A review of Marcel's solid state Firdac D/A converter.

Fig 5, 13Khz spectral line caused by ceramic cap on LT3042, input -20dB.

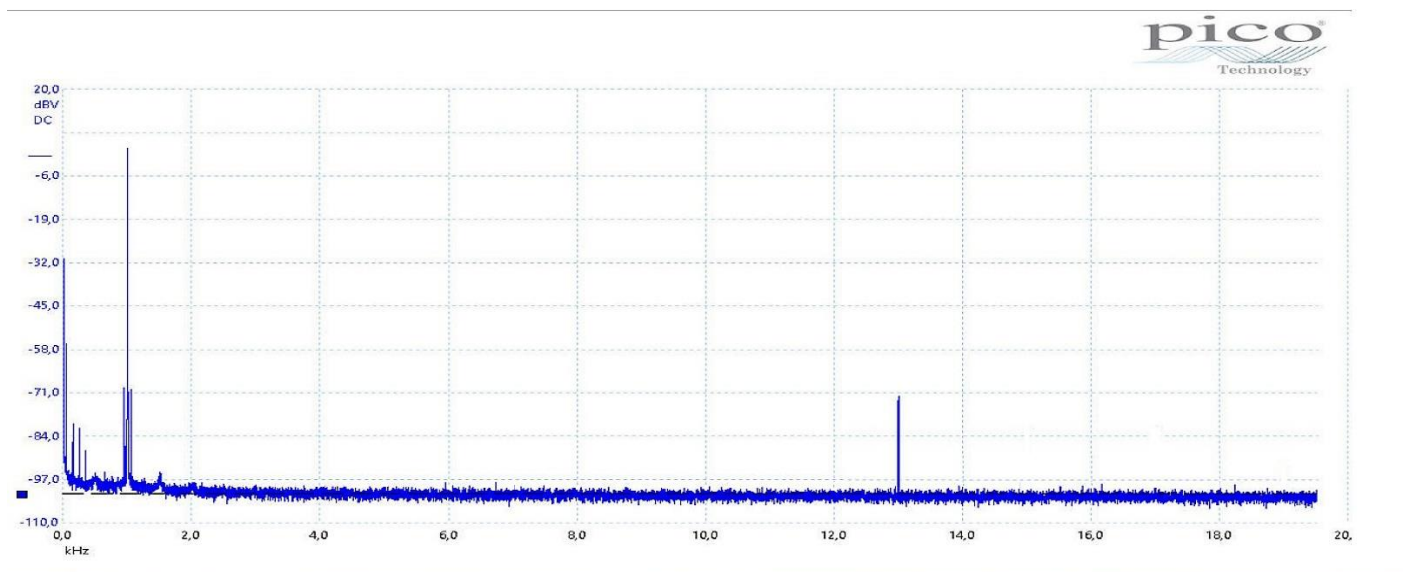
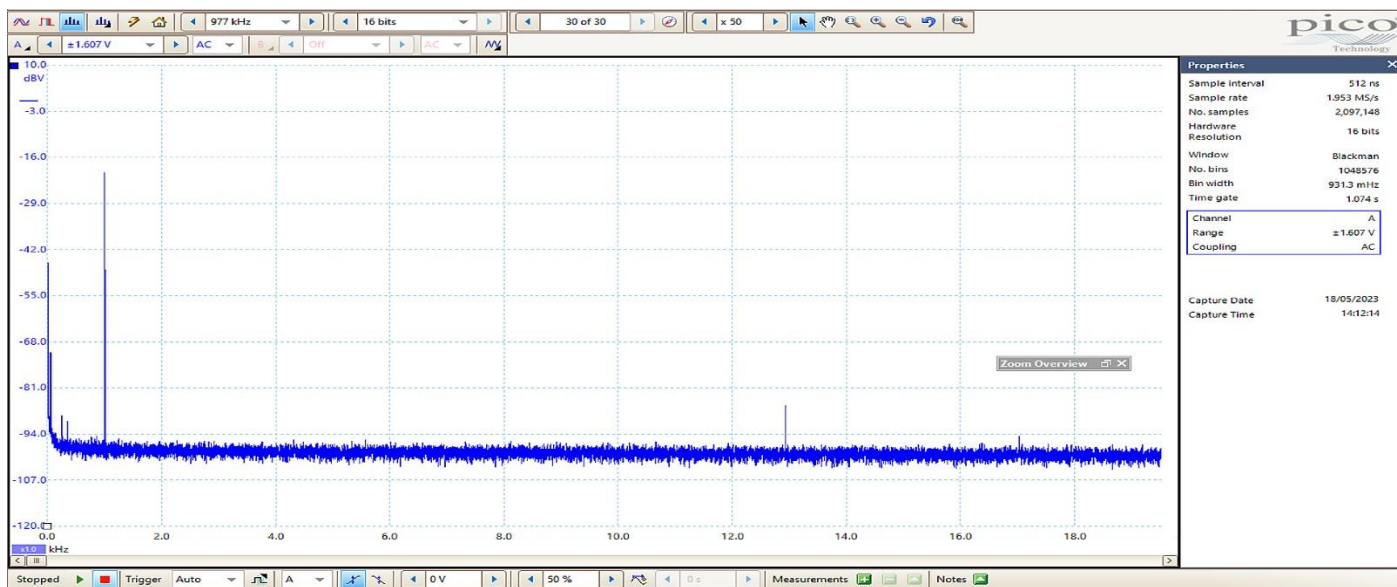
For the LT3042 a ceramic cap on the set pin turned out to be the wrong choice, probably because of piezoelectric effect leading to producing strange harmonics, see the 13Khz spectral line in Fig 4 and Fig 5. Replacing this cap with an electrolytic alu cap radically solved the problem for ever.

Fig 6, Reconstruction Filter with almost 8dB reduced noise over the original version.

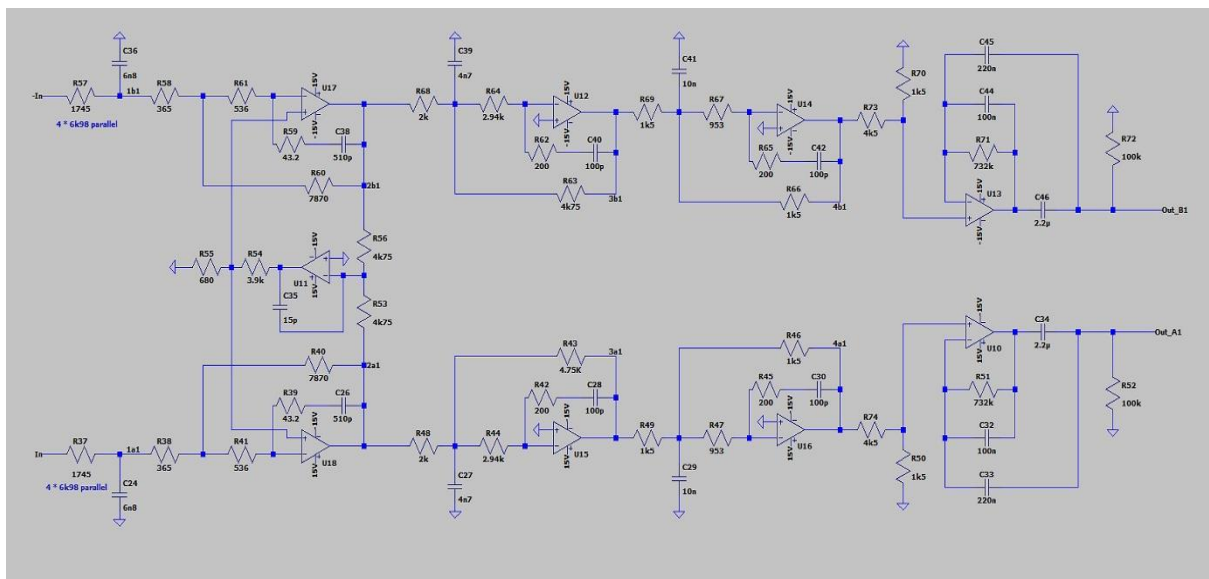
Since the second and the third stage were contributing most noise, I changed the first stage into giving 4 times more gain, and at the end of the filter I divided the output by 4 to get the same original gain. At the same time the FR was kept intact up to 80Khz.

But I wasn't yet satisfied with the above figures, because it was easy to calculate that the reconstruction filter was still worsening the Dac's output noise by some 2.5dB, and for such an excellent digital design it could be beneficial from a sound reproduction perspective, to go as low as possible for an overall balanced S/N between digital and analogue.

So I decided to change all components around reconstruction filter's stage 1 by a factor 4.6, expecting to reducing the overall filter's noise by another 2.6dB.

This implied reducing the Firdac resistors from 32k4 into 6k98.

Below is the circuit diagram showing how the complete filter became after that, including the 4 times larger gain for stage one and bringing gain back to its original value right before the output buffer.

Fig 8, Noise level reconstruction filter, switch 1 open,

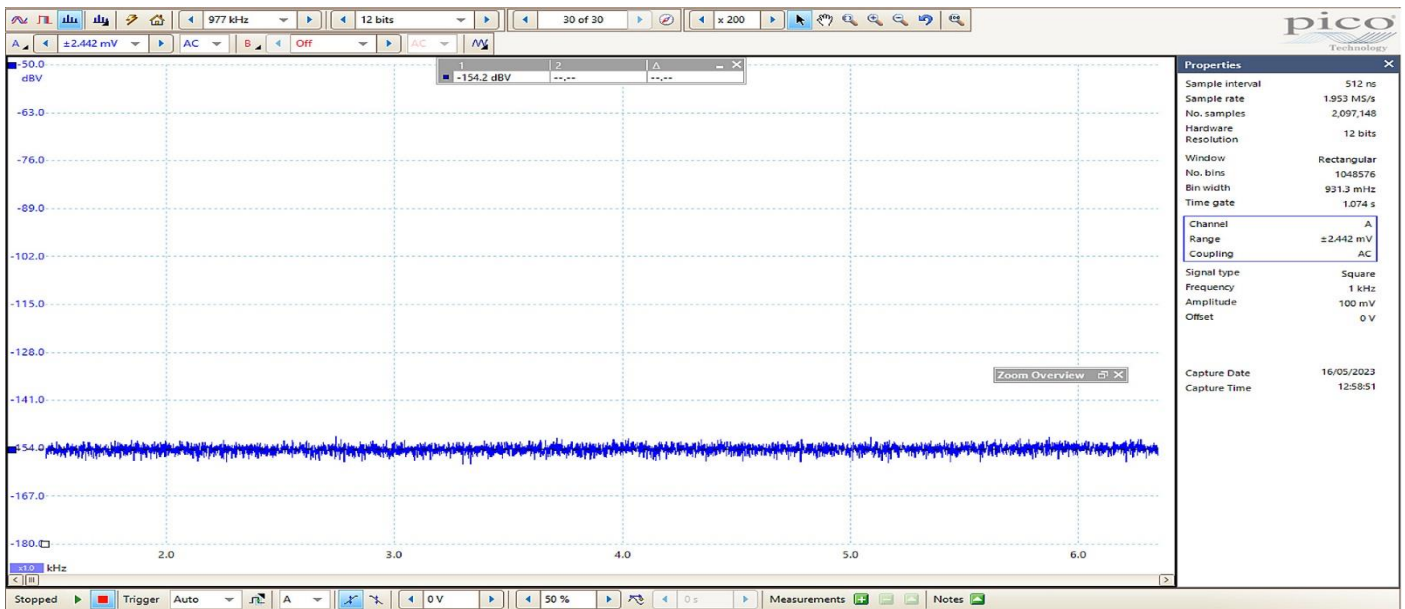
Calculating the Firdac's own noise in isolation, by taking the -154.2dB/rtHz reconstruction filter's noise from Fig 8 out of the measured overall -148.8dB/rtHz, gave 150.3dB/rtHz.

The reconstruction filter therefore is still worsening the Firdac's noise by 1.5dB from -150.3dB/rtHz to -148.8dB/rtHz.
